# Staff Report

**Re:** **Development Permit Application** under provisions of the Multi-unit Residential Development Permit Area (DPA 5) and a **Development Variance Permit** to allow an additional 1.25 metres height for property legally described as Plan EPP107675, District Lot 48, Lot 1, PID 031-401-244, with a street address of 118 Edgewood Drive

- 1) Development Permit under the provisions of the Multi-unit Residential Development Permit Area (DPA 5) for the construction of 12 town homes on Edgewood Drive (File # DP 2021-04); and
- 2) Development Variance Permit to allow an additional 1.25 metres height, increasing the maximum allowable height from 10.5 metres to 11.75 metres (File# DVP 2021-03).

Figure 5 Front elevation showing request for additional height

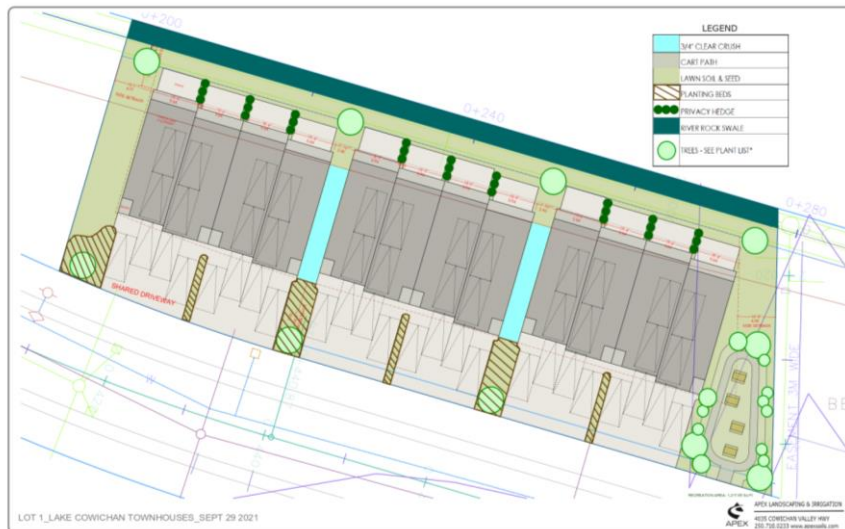
Roof lines are varied, alternating between shed style and gable styles. This design feature is the rationale for the accompanying development variance permit request raising the maximum allowable height by 1.25 metres.

The applicant requests an additional 1.25 metres in height to provide enhanced design aesthetics to the roofs of three-story townhomes. Under typical conditions such a request might not be necessary, however, in this case the first story is taller than a typical residential floor to accommodate a taller ceiling height for recreational vehicles.

- a. Vary by 1.25 metres the maximum height, resulting in an increase from 10.5 metres to 11.75 metres, for the property legally described as Plan EPP107675, District Lot 48, Lot 1, PID 031-401-244, with a street address of 118 Edgewood Drive.
